NOTICE OF REVISION (NOR)		1. DATE (YYMMDD) 97-08-08	Form Approved OMB No. 0704-0188
THIS REVISION DESCRIBED BELOW HAS BEEN AUTHORIZED FOR THE DOCUMENT LISTED.			
Public reporting burden for this collection is estimated to average 2 hours per response, including the time for reviewing instructions, searching existing data sources, gathering and maintaining the data needed, and completing and reviewing the collection of information. Send comments regarding this burden estimate or any other aspect of this collection of information, including suggestions for reducing this burden, to Department of Defense, Washington Headquarters Services, Directorate for Information Operations and Reports, 1215 Jefferson Davis Highway, Suite 1204, Arlington, VA 22202-4302, and to the Office of Management and Budget, Paperwork Reduction Project (0704-0188), Washington, DC 20503. PLEASE DO NOT RETURN YOUR COMPLETED FORM TO EITHER OF THESE ADDRESSES. RETURN COMPLETED FORM TO THE GOVERNMENT ISSUING CONTRACTING OFFICER FOR THE CONTRACT/ PROCURING ACTIVITY NUMBER LISTED IN ITEM 2 OF THIS FORM.		2. PROCURING ACTIVITY NO.

3. DODAAC	
4. ORIGINATOR	b. ADDRESS (<i>Street, City, State, Zip Code</i>)	5. CAGE CODE

FIGURE A-1

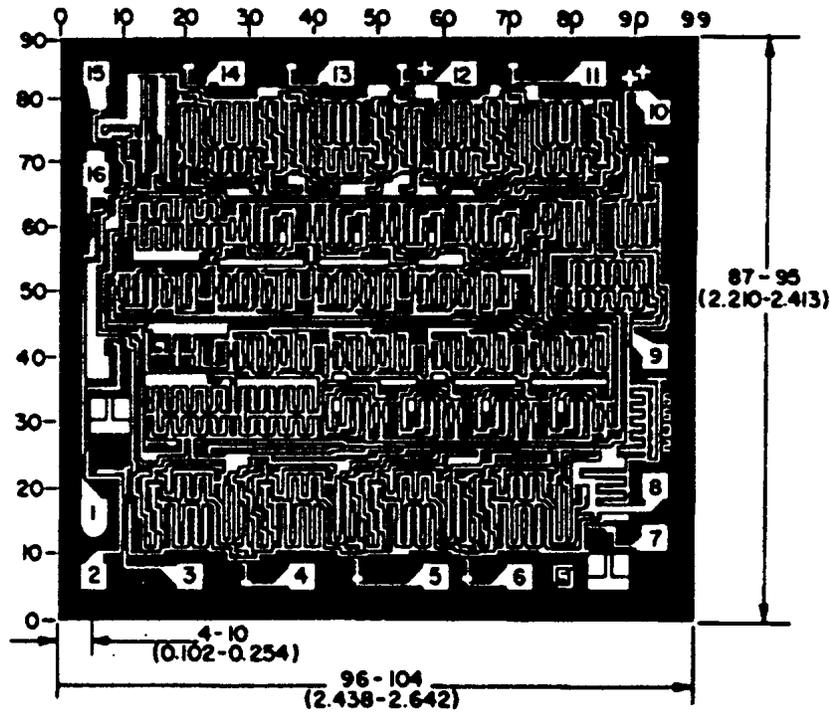
11. ECP NO. No users listed.			
12. CONFIGURATION ITEM (OR SYSTEM) TO WHICH ECP APPLIES All			
13. DESCRIPTION OF REVISION			
<p>Sheet 1: Revisions ltr column; add "B". Revisions description column; add "Changes in accordance with NOR 5962-R424-97". Revisions date column; add "97-08-08". Revision level block; add "B". Rev status of sheets; for sheets 23 change from "A" to "B". Rev status of sheets; for sheets 24 change from "A" to "B".</p> <p>Sheet 23: NOR 5962-R270-97 sheet 7 of Appendix A for Die Physical Dimensions for Die Thickness change from "21 +/-1 mils" to "20 +/-1 mils" Revision Level Block: change from "A" to "B"</p> <p>Sheet 24: NOR 5962-R270-97 sheet 8 of Appendix A for Interface Materials for Glassivation Type change from "Phosphorous doped SiO2" to "PSG" and for Assembly Related Information for Substrate Potential change from "Tied to V_{SS}" to "Floating or Tied to V_{DD}" Revision Level Block: change from "A" to "B"</p>

Substrate Potential: Tied to VSS.
Special assembly instructions: Bond pad #16 (VDD) first
